MODIFICATION No.: 23432K3129

T I T L E : AIR CONDITIONING - CARGO COMPARTMENT HEATING - MODIFY THE HEAT

CONTROLLER (10HC) FOR AFT CARGO COMPARTMENT

SERVICE BULLETIN No.: A320-21-1068

Location of AFT Cargo Heat Controller 10HC Figure 1

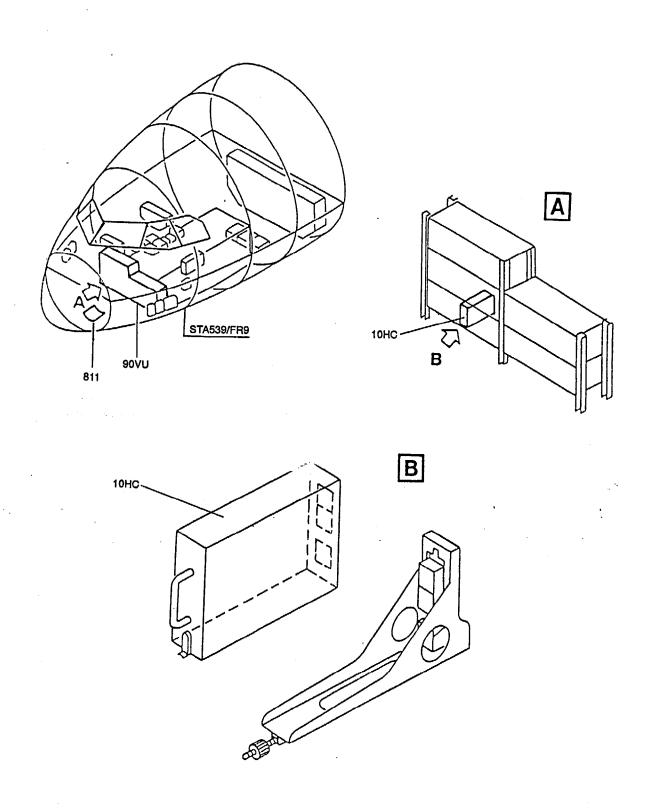
Refer to Figure 1

- (1) Remove the cargo heat controller (10HC), PN 600611-00-505 in accordance with the AMM 21-43-34, P. Block 401.
- (2) Modify the cargo heat controller (10HC) as per Para. 2.F.
- (3) Install the modified cargo heat controller (10HC), PN 600611-00-506 in accordance with the AMM 21-43-34, P. Block 401.
